**Response to queries raised by Bidders for system bid document of MGS-SEBN & CPBH (Excluding NKWD-DGO section)**

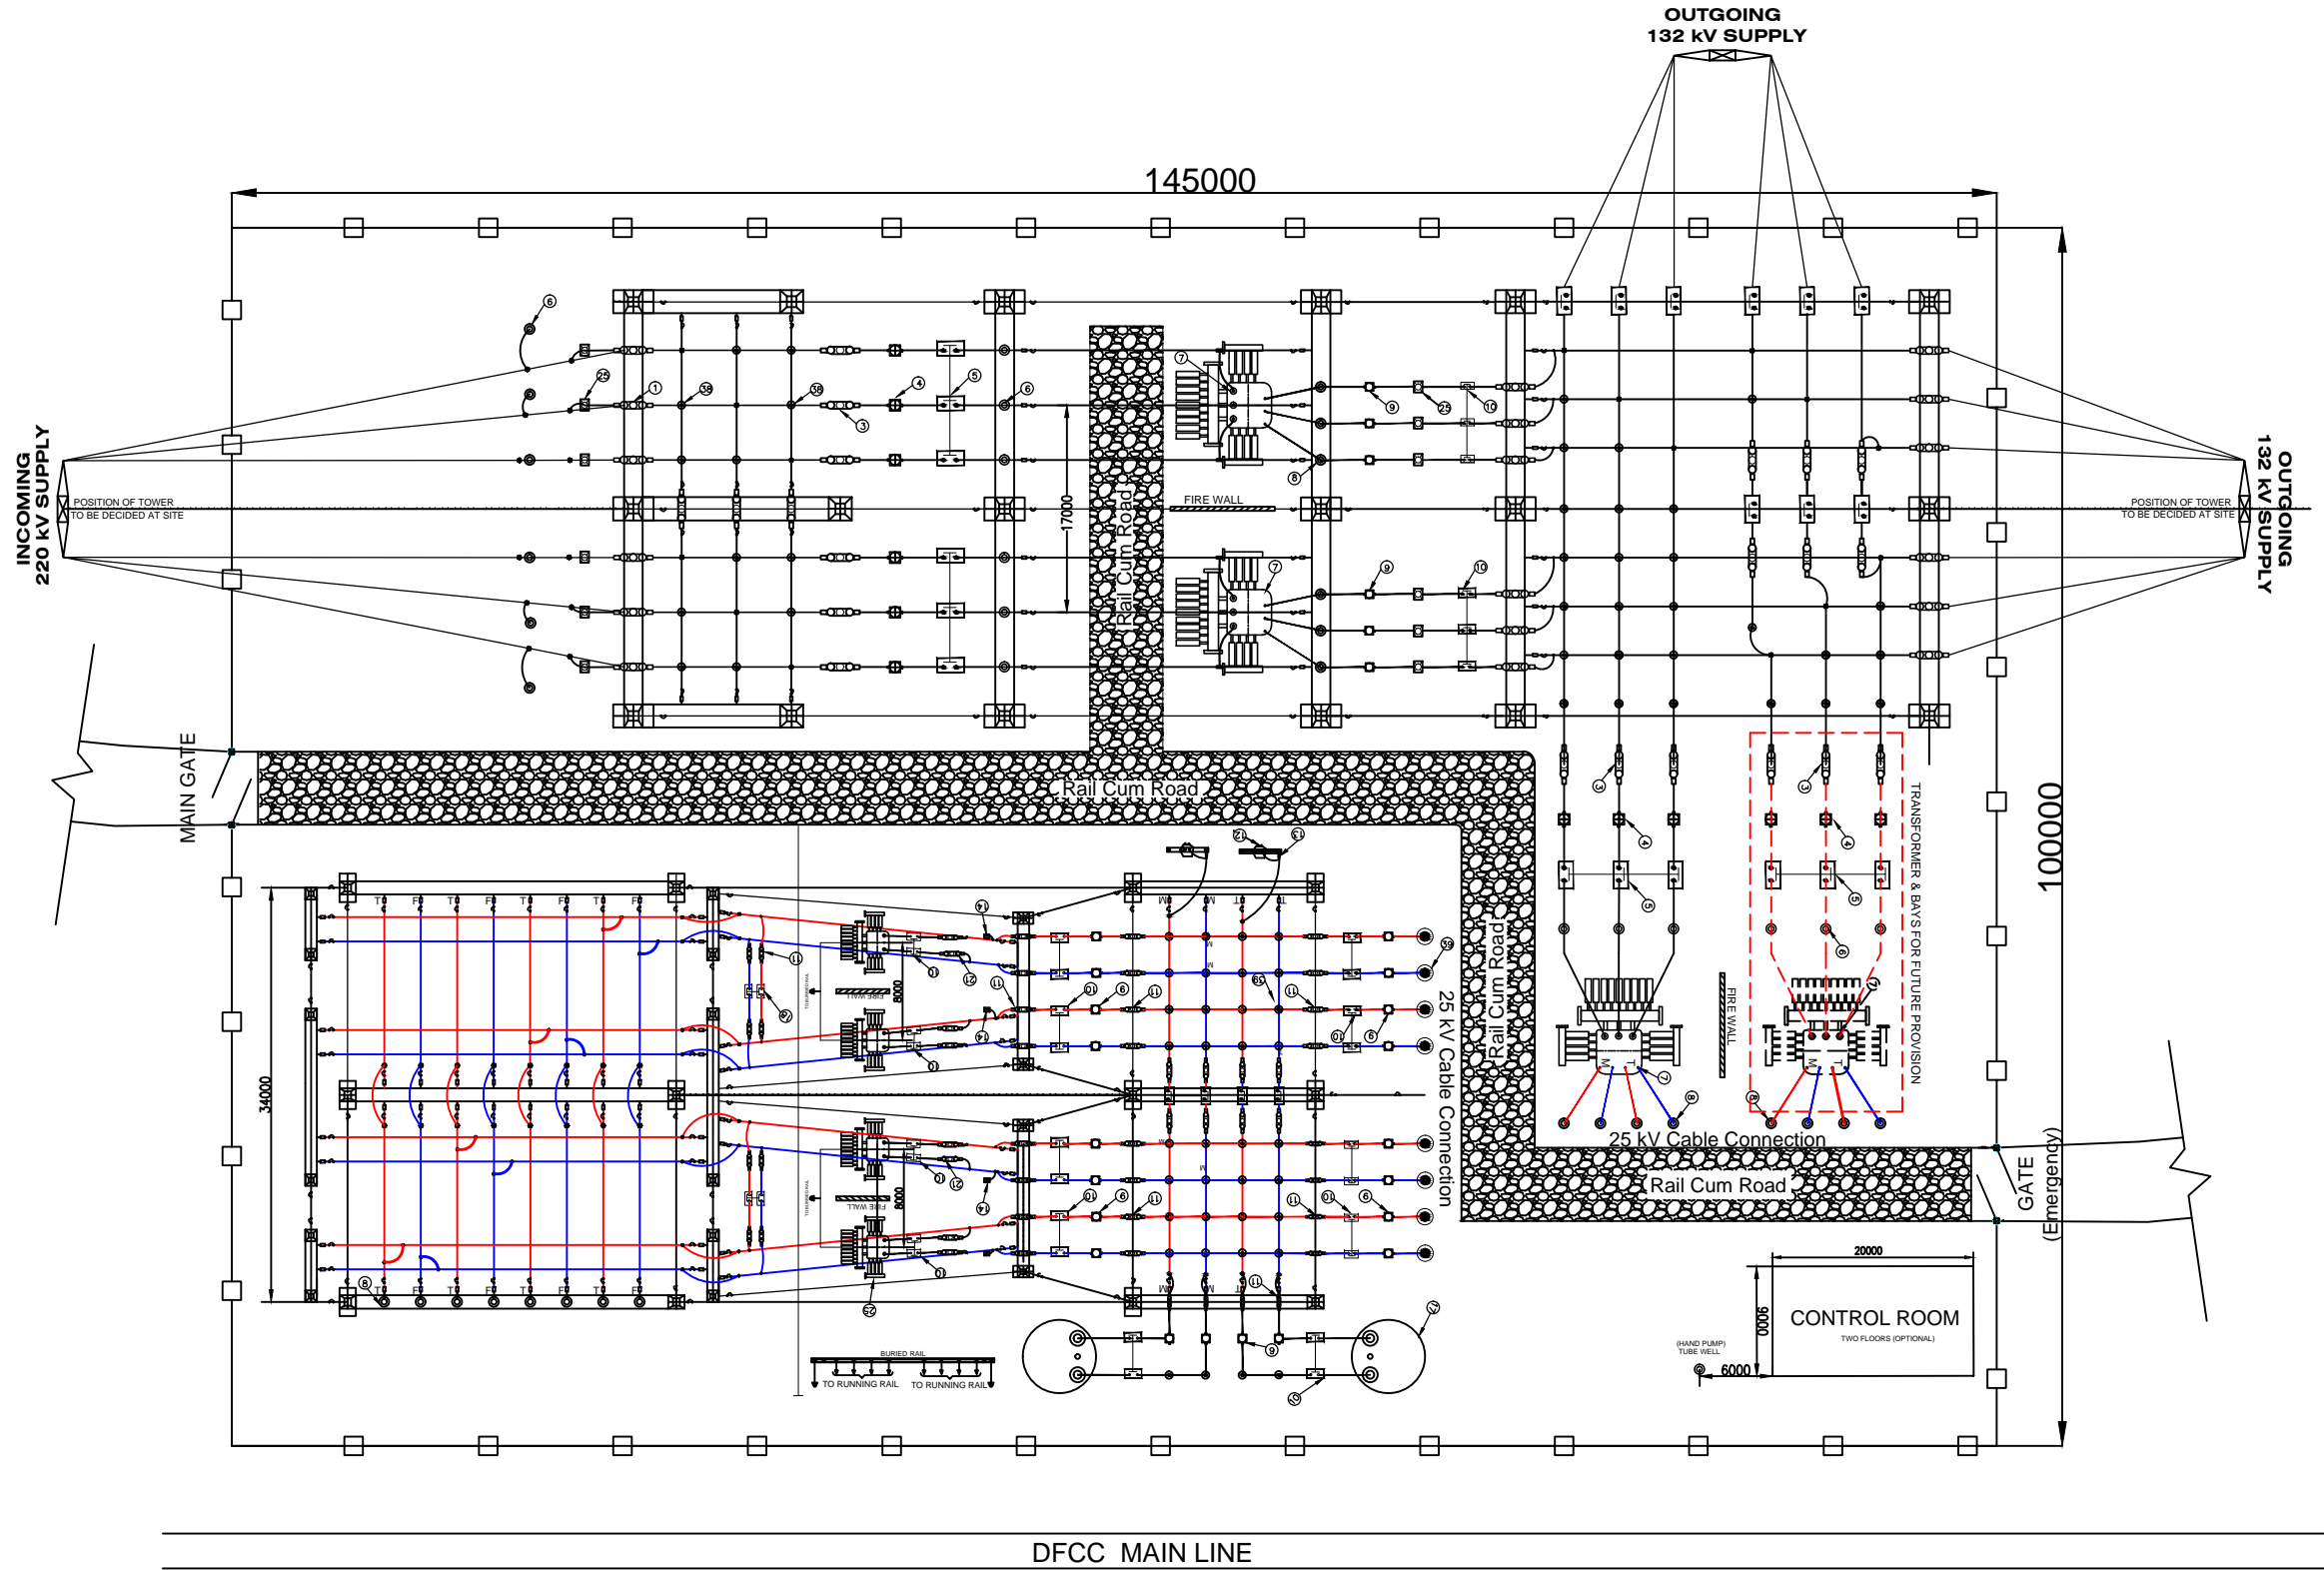
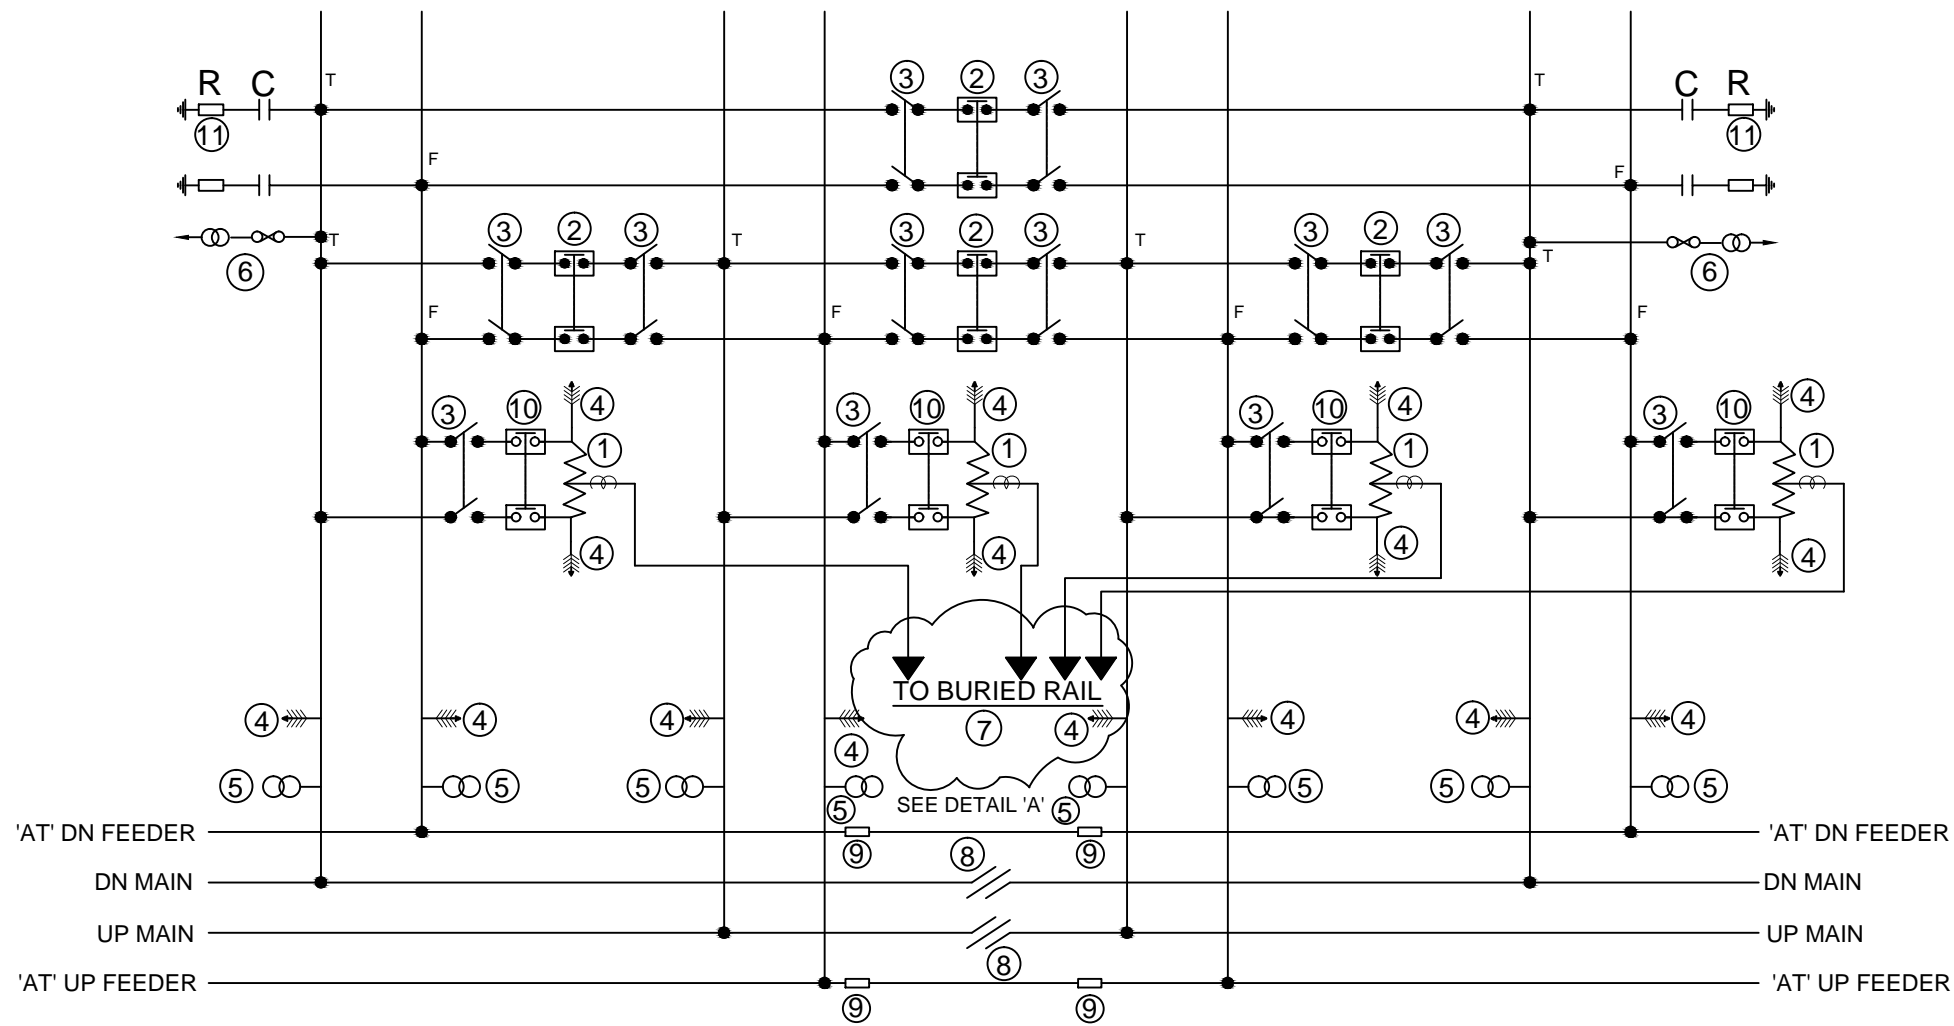
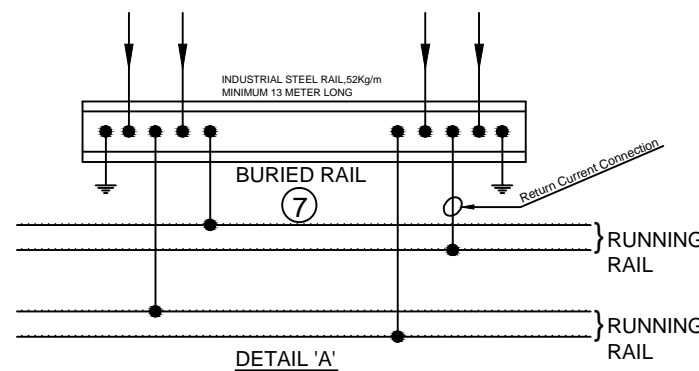
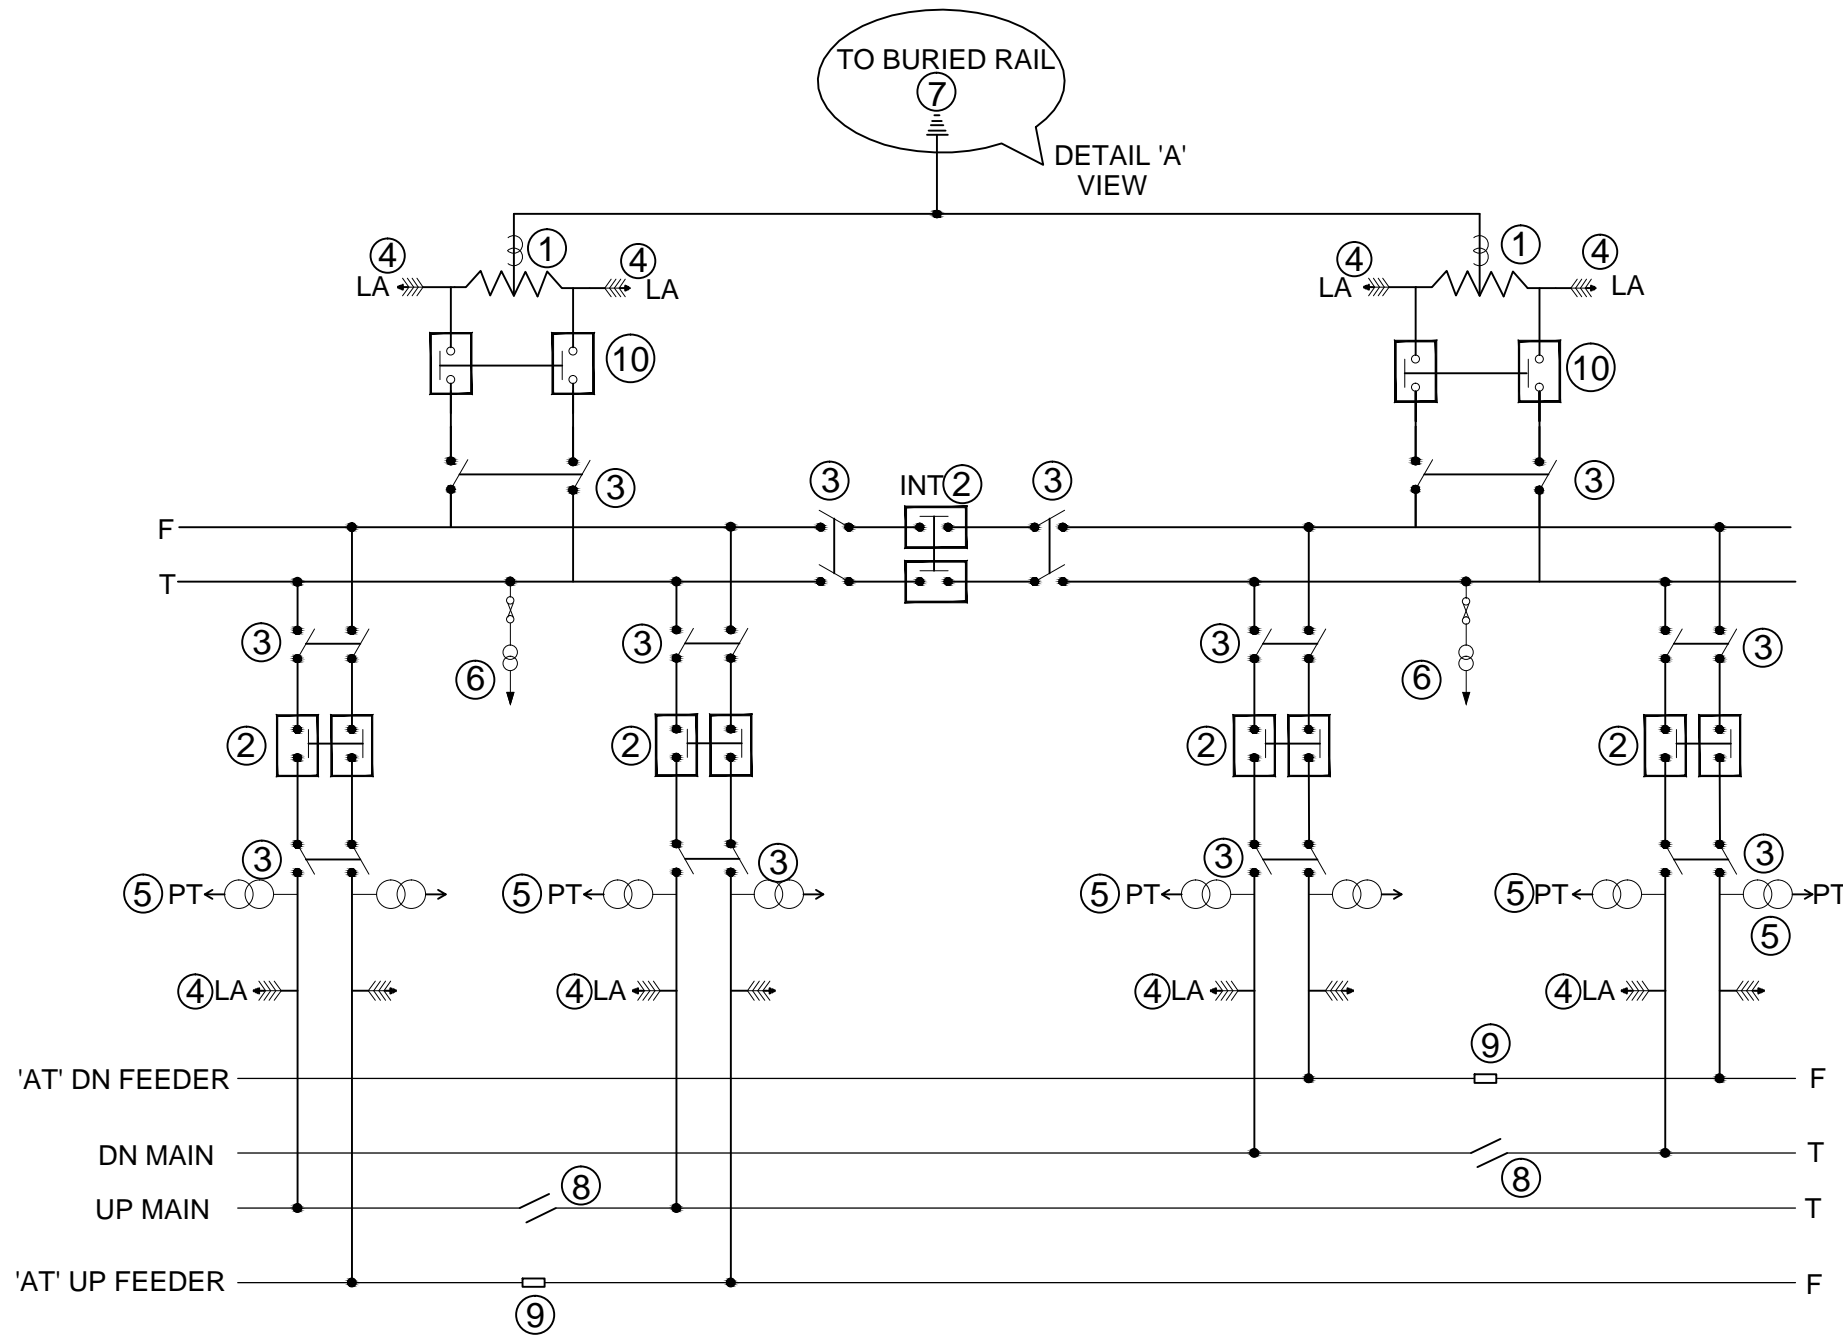
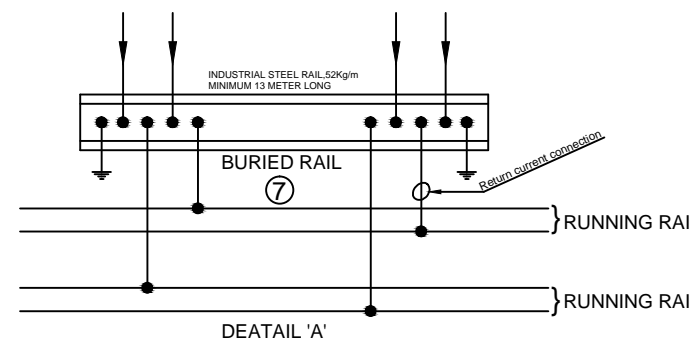
S.N.	Reference to Bid Document	Available Terms	Clarification sought by Bidder	DFCC's Response																		
57	Pat 2, Vol. 9, PS Electrical, Appendix-A to D	Schematic, TSS, SP & SSP drawings	The drawings are not legible. We request you to issue the drawings in A3 size or in AutoCAD format.	The drawings in pdf format is attached.																		
58	Part 3, Section VII, PC, Sub-clause 13.8, Price Variation Pg 17 of 53	Presently price variation formula for Copper conductor and Transformers are given	Steel structures required for OHE constitute a major portion of the cost in Electrical. We request to provide PV formula for Steel structures.	Request not accepted. The provisions of Bid document shall prevail.																		
59	Part 5, Price schedule, Schedule B Pg 7 of 56	Apportionment of contract price for payments of Electrical Signal & Telecommunication and Building and Structure works
